Application for Licence Amendment

Part V Division 3 of the *Environmental Protection Act 1986*

Licence Number	L8578/2011/1
Licence Holder	Regis Resources Limited
ACN	009 174 761
File Number	2011/003002-1
Premises	Duketon Gold Project Legal description – Mining tenements M38/114, M38/237, M38/250, M38/283, M38/292, M38/302, M38/303, M38/341, M38/343, M38/352, M38/354, M38/407, M38/498, M38/499, M38/500, M38/589, M38/630, M38/802, M38/943, M38/1091, M38/1249, M38/1250, M38/1251, M38/1257, M38/1258, M38/1259, M38/1260, M38/1261, M38/1262, M38/1263, M38/1277, L38/201, L38/202, L38/203, L38/204 and L38/216. As depicted by Schedule 1 attached to the revised licence.
Date of Report	07 February 2023
Proposed Decision	Intent to grant revised licence

Figure 2: Existing and proposed discharge points

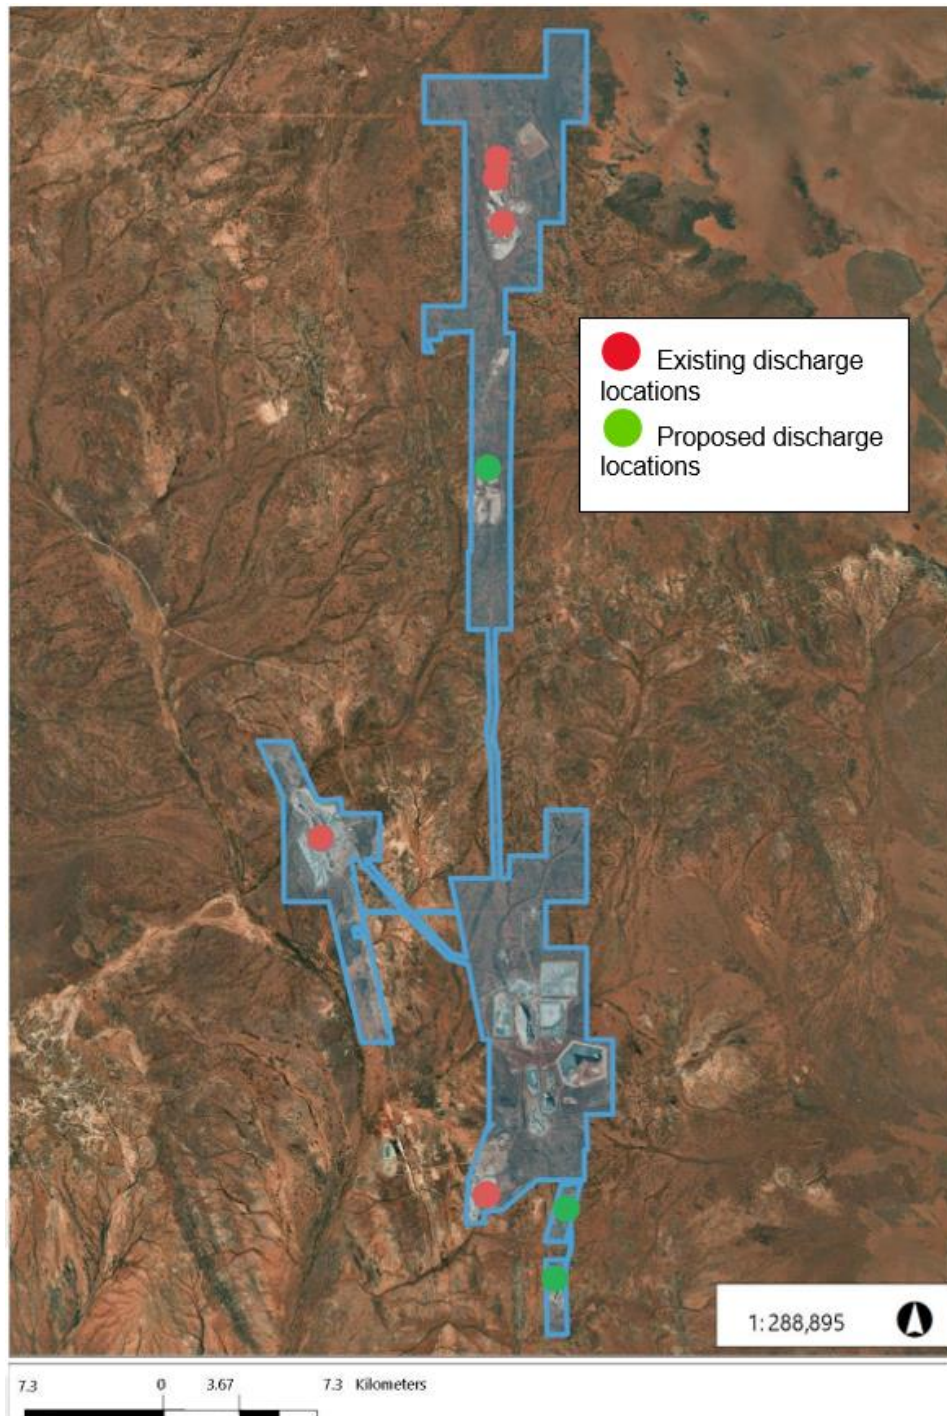
The applicant is seeking three additional mine dewatering discharge locations – Cooper’s Pit, Russell’s Find and Reichelt’s Find to be included on the existing licence. The applicant is seeking the flexibility to dewater from any location across site, to any of these discharge points depending on operational requirements. As the operational requirements will change as the mining strategy evolves, exact volumes of water to be discharged to particular discharge points, and the quality of that water, has not been fully determined.

Water quality data for this location is limited. Data from 2012 showed that Reichelt’s Find contained a small pit lake with salinity of about 10,000mg/L TDS, while the ambient groundwater salinity was measured at around 1,200mg/L TDS, indicating that the pit is acting as a groundwater sink. No information was provided to demonstrate whether this is likely to change when this location becomes a discharge point. It is estimated that the pit has the capacity to store a further 1,500,000 m³ of water.

Water quality data for this location is also very sparse. Data from limited sampling undertaken in 2011 recorded the salinity of the pit lake water to be 4,600mg/L TDS while the ambient groundwater salinity was 1,200mg/L TDS. The report from this time also noted that arsenic in the pit lake water was 'elevated' (no specific data was provided). A hydrogeological assessment prepared in 2019 suggests that post-mining, Russell's Find will become a groundwater sink, however this assessment did not take into account that this location may be used as a dewatering discharge location.

Four samples of groundwater taken from around Cooper's pit between 2019 to 2021 indicate that ambient groundwater salinity at this location is 700 to 1,200mg/L TDS, pH is close to neutral and heavy metals are low. These groundwater quality parameters constitute potable to brackish water, which indicates that groundwater in this area is significantly better than many other areas of site and is of suitable quality for other beneficial uses such as stock watering. It has not been determined if this aquifer is currently being used for stock watering on the adjacent pastoral leases.

There is an additional risk of potentially impacting the groundwater at this discharge point due to there being no dedicated mine dewatering discharge pipeline. Instead, mine dewater will be transported using a pipeline that has a dual use for the transfer of process water between the processing plants. The only proposed controls to ensure that process water will not be discharged at this location will be operational. With these operational controls in place, it

The Delegated Officer considers this an appropriate level of risk for these activities, with the applicant's controls in place. However, to verify that the applicant's controls have been effective in mitigating this risk, the Delegated Officer deems it appropriate to apply a Total Cyanide limit and monitoring requirement at this discharge point only.

The Delegated Officer has applied water quality discharge limits for the key parameters of TDS, arsenic and pH to Russell's Find, Reichelt's Find and Cooper's pit discharge points (at the end of pipe), in line with the ANZECC and ARMCANZ (2000) stock water guidelines. This is in accordance with the department's policy of setting outcome-based conditions and allows the applicant to best determine how to manage their operation to meet them.
